700-, 701-, AND 702-TYPE CONNECTORS
AND
E, F, AND H CONNECTOR PRESSERS

1.001 This addendum supplements Section 081-852-130, Issue 4. Place this sheet ahead of Page 1 of this section.

1.002 This addendum is issued to revise Fig. 7.

Fig. 7—Checking E Connector Presser for Proper Press

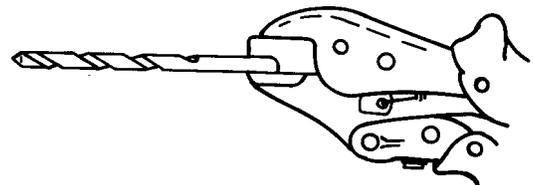
2.001 On Page 8, change Fig. 7 as follows:

1. USE SHANK OF 17/64 DRILL AS A GAUGE.
2. GRASP DRILL SHANK WITH E PRESSER AS SHOWN.
3. IF DRILL IS NOT FIRMLY GRASPED, THE PRESSER IS DEFECTIVE AND MUST NOT BE USED.

NOTE:
TRY DRILL BOTH WAYS TO FIND WIDEST SEPARATION.
